Delegated Report

Subject: Lingfield Road-Facilitate contra-flow cycling

LINGFIELD ROAD CONTRA-FLOW CYCLE LANE – VILLAGE

Statutory consultation - 18th February 2021

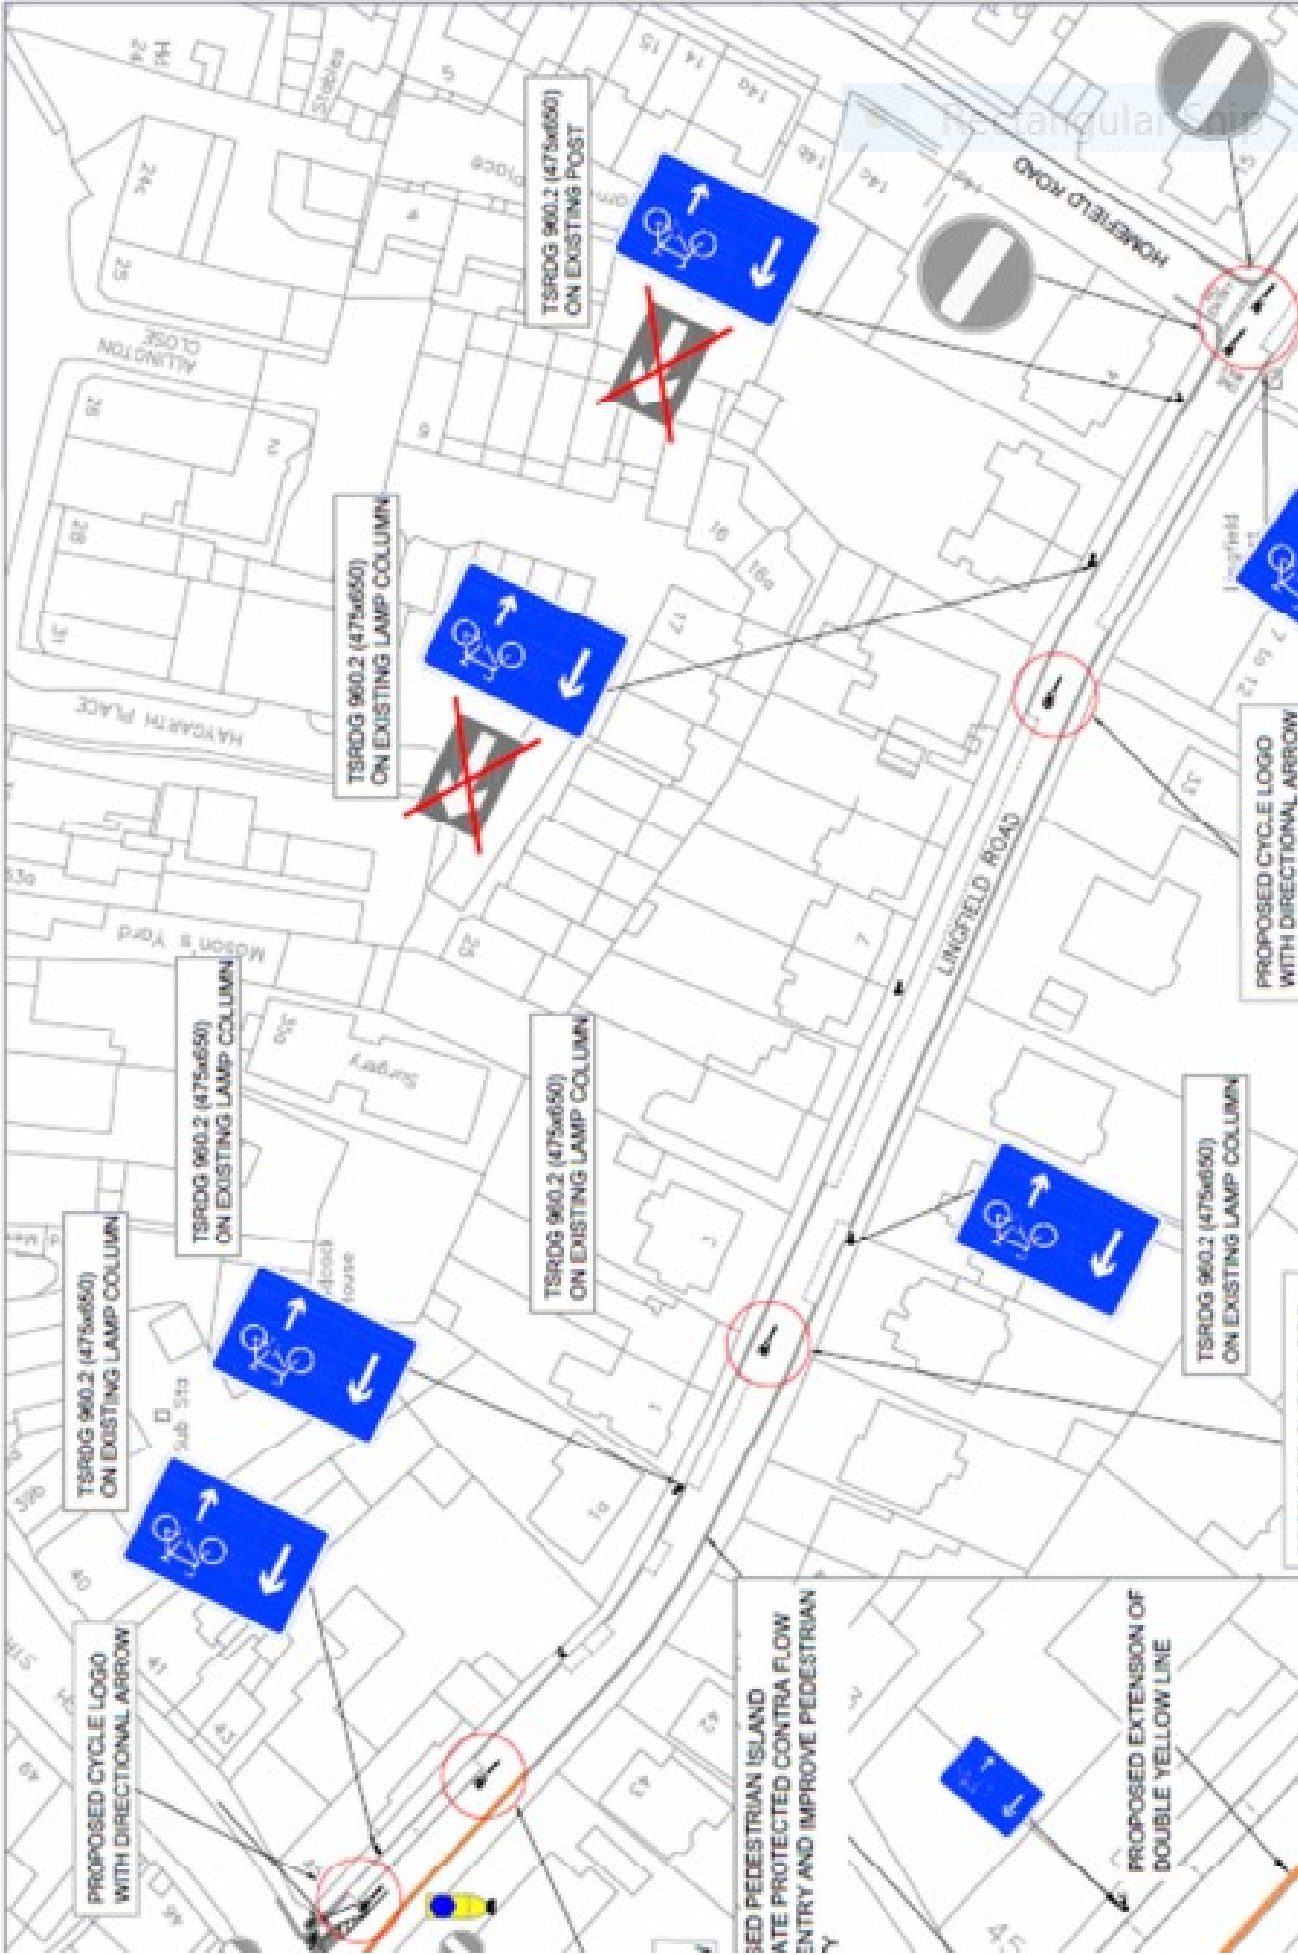
2. *Proposed buildout to narrow pedestrian crossing point on Southside Common Junction*

NOT WORTH THE EFFORT, A WASTE OF MONEY

3. *Proposed pedestrian island to create protected contra-flow cycle entry and improve pedestrian visibility*

THE PLAN DETAILS ARE TOO SMALL TO READ ALTHOUGH THE MUTUAL BENEFIT TO EITHER PARTY SEEMS UNWORKABLE.
